**FLORIDA DEPARTMENT OF  
ENVIRONMENTAL PROTECTION**  
CENTRAL DISTRICT  
3319 MAGUIRE BOULEVARD, SUITE 232  
ORLANDO, FLORIDA 32803-3767

OCD-SW-12-498

Osceola County – SW WACS # 89544  
J.E.D. Solid Waste Management Facility  
2012 Phase I Partial Closure Construction  
Approval of Certification of Construction Report

The Department has completed the review of the report titled “Construction Quality Assurance Certification Report, 2012 Phase I Partial Closure Construction,” submitted on your behalf by Weaver Boos Consultants Southeast, LLC. The report was dated October 30, 2012 and received by the Department on October 31, 2012. The report and DEP Form 62-701.900(2) were signed and sealed by Professional Engineer of Record, Mr. Jeffrey D. Schaffer, P.E., of Weaver Boos Consultants Southeast, LLC.

**ASR:**

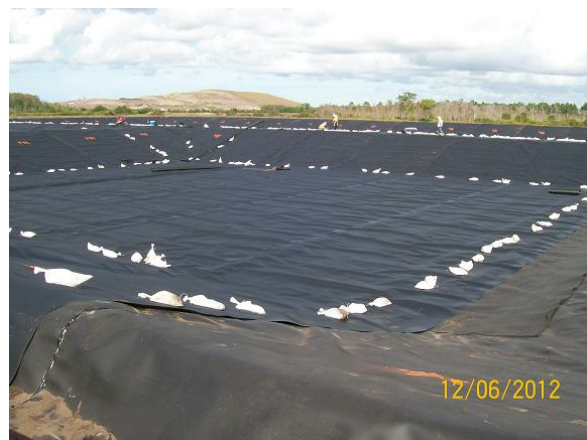
The ASR was not in operation at the time of this inspection. The area was in good order.
